Ref.	Request for Clarifications/Questions	Proposed Clarifications/Responses
1	1. Bill 1, MAIN CANAL 1, Item 1.1, line 5 Embankment (Dump truck 15ton, L=1.2km)1.2km means the length of the embankment is 1.2km, or dump site distance is 1.2km? Line 6 Waste Soil, will it be dumped on site or out of the construction site, no indication of dump site distance?	1.2km is the dump site distance in MC1 and is the average transport distance between the cutting section and the embankment section. The average transport distance in MC2 is 3.3km. Waste soil refers to the volume of soil to be disposed in or near construction site.
2	2. Bill 1, MAIN CANAL 1, Item 1.3, Line 1 Wire Mesh D=6mm, the unit is showing “m3”, usually it’s “m2” by common knowledge. Line 6 Support Post, does it mean support of the formworks or scaffold works?	Unit error in wire mesh! Should be changed to m ² . Unit error in Support Post. Should be changed to m ³ . Support Post and scaffolding are different temporary installations. It is the volume in which the support posts to be installed. (Area of slab to be supported * height of post) The bidder will estimate how many posts are needed based on the volume.

Ref.	Request for

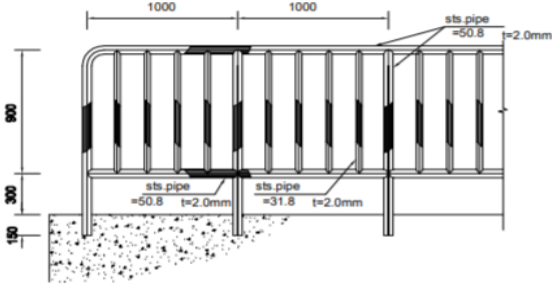
Ref.	Request for Clarifications/Questions	Proposed Clarifications/Responses															
19	Please provide standard details	<p data-bbox="1121 264 1724 293">Refer to the design below with different length scale.</p> <div data-bbox="1150 331 1705 787" style="text-align: center;"> <p>Detail a Guardrail</p>  <p>Material List (1m/unit)</p>

<table><tr> <th>NO</th> <th>Size</th> <th>Quality</th> <th>Length</th> <th>Remark</th> </tr><tr> <td>1</td> <td>∅50.8,t=2m/m</td> <td>STS316L</td> <td>3.36m</td> <td></td> </tr><tr> <td>2</td> <td>∅31.8,t=2m/m</td> <td>STS316L</td> <td>3.60m</td> <td></td> </tr></table>
